SHOWGROUND PRECINCT EAST

DESIGN EXCELLENCE ADDENDUM REPORT

STATE SIGNIFICANT DEVELOPMENT APPLICATION

AUGUST 2024

Figure 2: Artwork of Native Birds (Binyang) Dreaming Stories (Source: Uncle Danny Eastwood and Mr Jamie Eastwood)

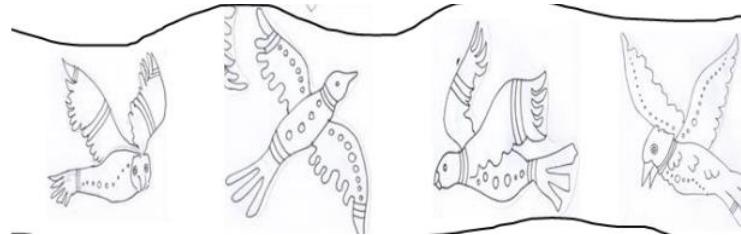
1. Further develop the publicly accessible pedestrian link between Building D2 and E1: a. Explore further opportunities to reference the nearby Cattai Creek. b. Demonstrate how the link connects visually and/or physically across the precinct and on to adjoining sites, specifically the Doran Drive Precinct.	Response – Charlie Robinson, Director at Land and Form (RLA 5898) & Lotti Wilkinson, Head of Planning at Deicorp The design development of the project has evolved with careful consideration and recognition to the importance of the First Nations historic and ongoing care of Country. As discussed in the Connecting with Country Report submitted with the SSDA, indigenous artists Uncle Danny Eastwood and Mr Jamie Eastwood (Darug) were engaged by Deicorp to include the design input from Indigenous Aboriginal communities encompasses a rich tapestry of knowledge, traditions, and contemporary innovations to deliver a public art strategy that integrates Connection to Country with the design of the development. Community workshops and advice from Danny Eastwood and Jamie Eastwood identified opportunities for Connecting with Country through public art and landscape within the Precinct. The following themes were identified and have been incorporated into the proposal: • Cattai Creek • Native Birds (Binyang) Dreaming Stories • Bediagal (Darug) Language • Native Flora and Fauna

The curatorial team has implemented local Indigenous bird dreaming stories, which are the main content for the public art within in the publicly accessible link between Buildings D2 and E1. The publicly accessible link and art installation will include indigenous language bird names, totems and design throughout the pathway that represents Cattai Creek.

Figure 6: Diagram demonstrating the communal open space areas which receive in excess of two hours of solar access at midwinter (Source: Turner Studio)

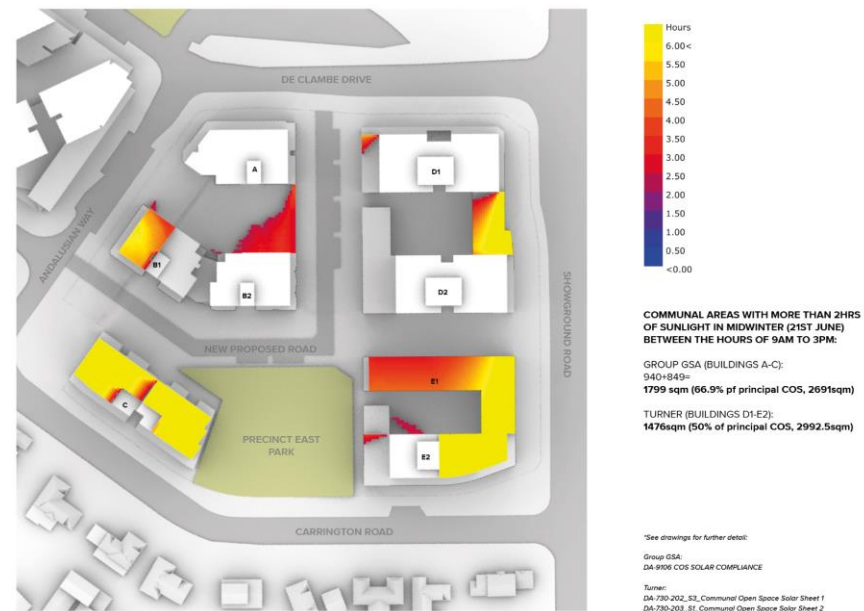
7. Explore adjusting building envelopes to increase solar access to the communal courtyards during the winter. If increased solar access cannot be achieved, demonstrate how this highly seasonal environment can support a lush landscape and a variety of uses throughout the year for residents.

A compliant quantum of solar access is achieved to the communal open spaces as required by the ADG. Specifically, for Buildings A, B and C 66.9% of the principle communal open space (equating to 1,799sqm out of a total 2,691sqm) achieves two hours of solar at midwinter and for Buildings D and E, 51.1% of the principle communal open space similarly achieves this (equating to 1,529sqm out of a total 2,992.5sqm). This is demonstrated in the figure below.

Figure 7: Lobby locations for Buildings D & E shown in orange (Source: Turner Studio)

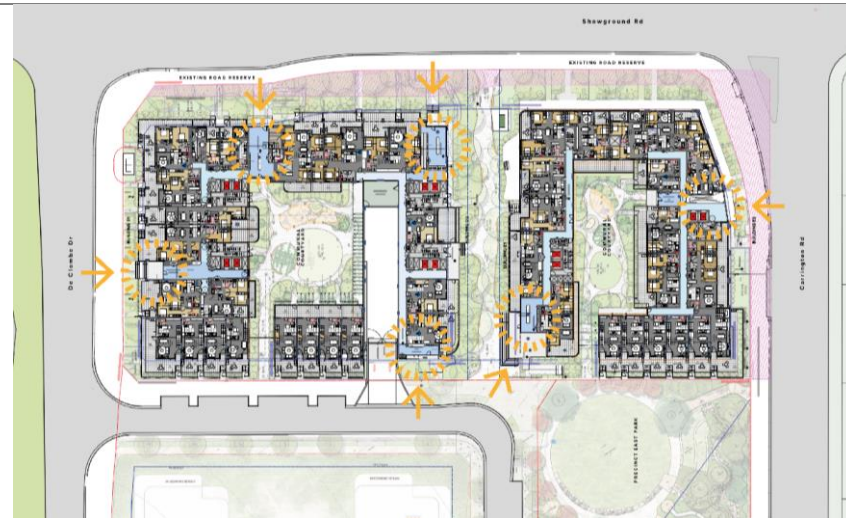
9. Ensure the building entrances and proposed public domain are all congruent with surrounding public domain works by others, particularly the internal streets (Lot 1) and park (Lot 2).

The consolidation of car park entries and loading docks for Buildings D and E into a single entry/exit point on the subdivided road has effectively removed traffic movement conflicts at the western end of the publicly accessible pedestrian link. The loading dock, located within the basement, ensures trucks can safely enter and exit the site in a forward direction. Strategically placed lobby entries at prominent corners offer direct street addresses and are further highlighted with feature awnings for intuitive and logical wayfinding.

Figure 13: Reconfigured communal facility to restore the visual connection between the communal courtyard and publicly accessible pedestrian link (Source: Turner Studio)

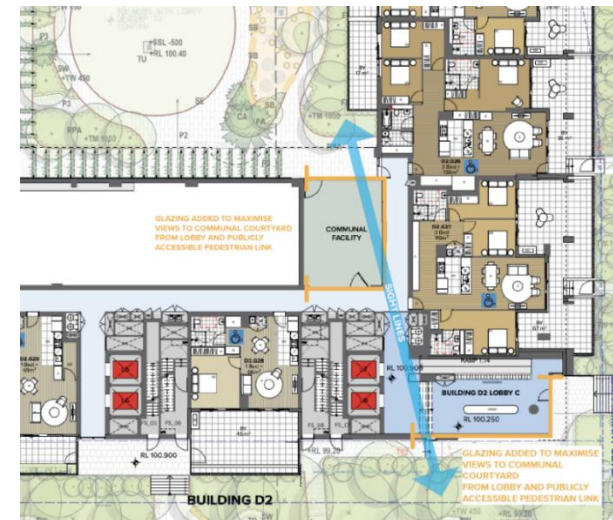
- Reconfigure the Communal Facility for Building D2 to restore the visual connection between the Communal Courtyard and publicly accessible pedestrian link that was evident in the first SDRP presentation.
- Restore the entrances to the two Building C lobbies from Carrington Road that were evident in the first SDRP presentation to improve activation of this streetscape.

- The glazing extent in the indoor communal facility has been increased to maximise sight lines between the communal area, D2 lobby and the publicly accessible pedestrian link beyond. Refer to the figure below.

Figure 14: Ground floor plan showing building entries from Carrington Road (Source: Group GSA)

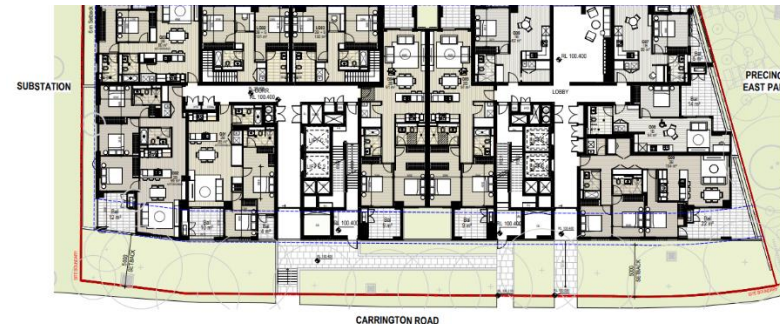
13. While changes to the lobbies have improved the interface in Building B, other changes have reduced the activation of the public realm and minimised sightlines through the lobbies into the landscaped courtyards. Explore opportunities to improve visibility and activation around these primary circulation points:

- a. The design of Building C has been amended to provide access from both ground floor lobbies to Carrington Road. Access and sightlines have been improved to create a greater sense of connectivity and choice of access for residents and visitors. The additional entries are provided within the site's 5m setback and have been designed in close collaboration with landscape architects Land and Form to ensure the stairs and access pathways are nestled within planters and trees.

Figure 16: Window screens for solar shading located on Building D2 (left) and Building E2 (right) north elevation (Source: Turner Studio)

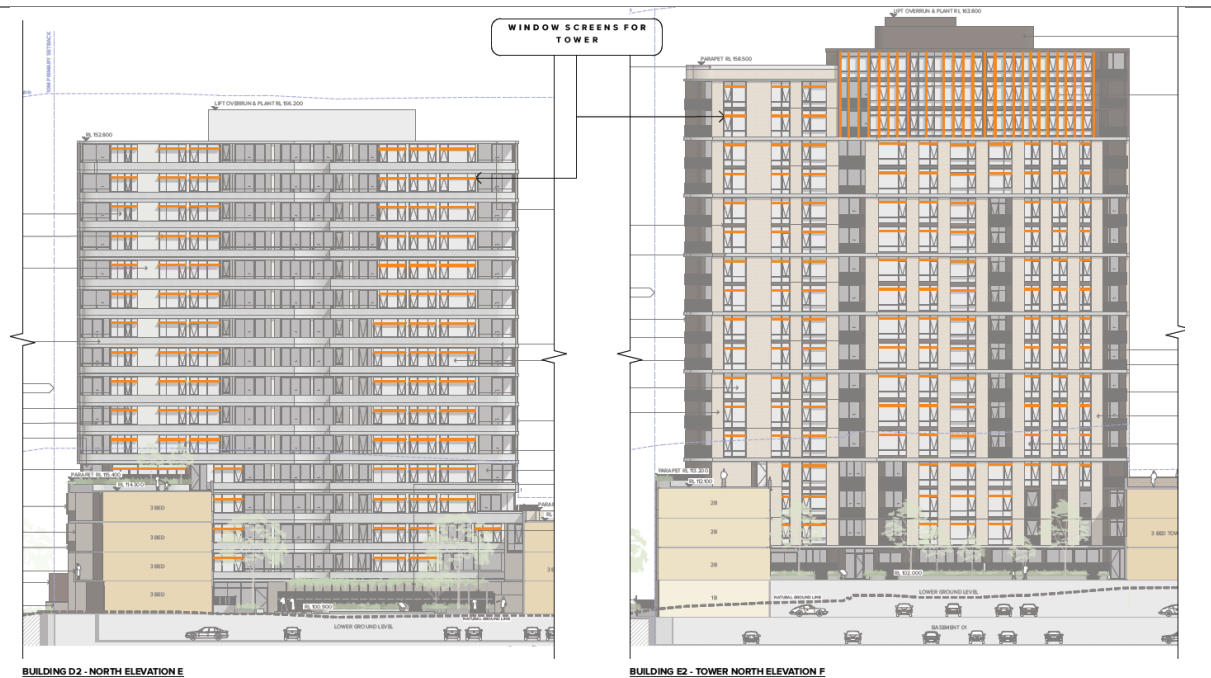
15. Effective sun shading still needs to be addressed, particularly along the northern and western facades of the buildings. Meaningful sun shading devices will greatly reduce summer heat gain and improve energy performance. Their design could also help increase façade articulation and provide greater variation across the different elevations.

Integrating horizontal solar shading louvers along the northern and western facades of the buildings will help maintain apartments' thermal comfort levels. Additionally, this approach creates a dynamic facade typology and enhances the visual interest of the built form.

Refer to the elevations below indicating the location of additional solar shading screens on Buildings D2 and E2.

Figure 23: CGI of western extent of Building C
(Source: Ivolve Studios)

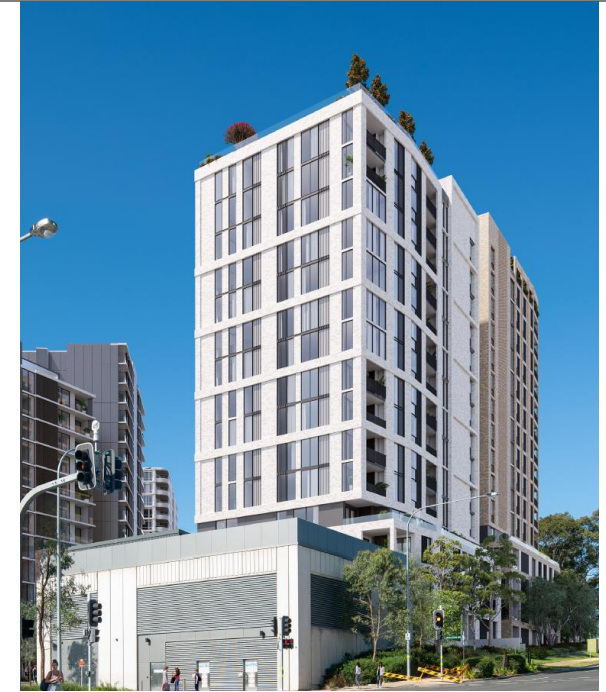
16. Ensure the proposed materials are selected for their durability, quality and maintenance. This could include different types of concrete (such as the lower carbon and paler ENVISIA) or tinted concrete, rather than painted finishes which can be difficult to maintain on taller buildings and require ongoing replacement.

In relation to Building C, a palette of prefinished materials has been selected, with key materials including brick and/or precast with brick slips to provide a consistent masonry finish. Two tones of brick are provided with a white mix for the western tower and a sand mix for the eastern tower. A precast panel with brick slips is located on the core faces in the northern elevation enhanced with textured brick patterns adding more detail to this elevation.
